CONNECTICUT YANKEE ATOMIC POWER COMPANY

Haddam Neck Plant
Proposed Radiological Effluent Technical Specifications
and Offsite Dose Calculation Manual

ENCLOSURE 1

RESPONSES TO SPECIFIC COMMENTS

FIGURE 4

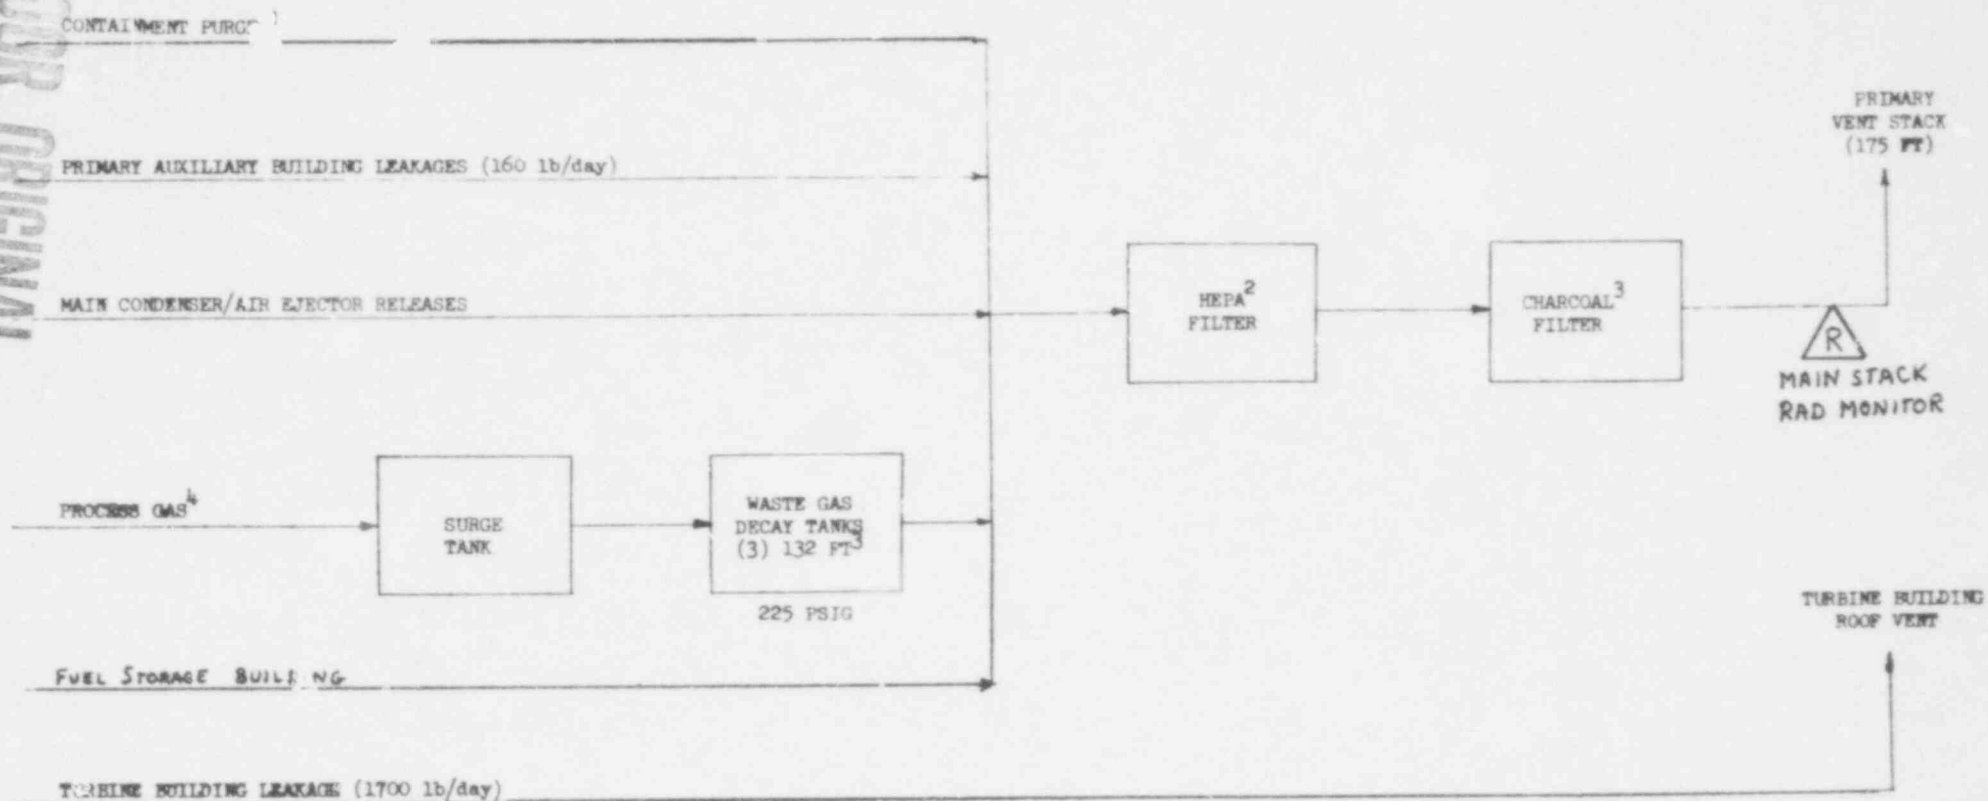
CYAPCO shall show all gaseous release points on the flow diagrams and justify not monitoring any unmonitored releases.

Response

Station radiological area ventilation, except for insignificant levels from the turbine building and service building, is exhausted through the main stack, and, thus, is monitored.

There exists a separate roof vent over the boric acid storage area in the Primary Auxiliary Building (PAB). However, this vent has been tagged closed and the power leads to the fan and louver mechanism disconnected to prevent operation. Thus, the ventilation from this area is directed with the remainder of the PAB ventilation to the main stack.
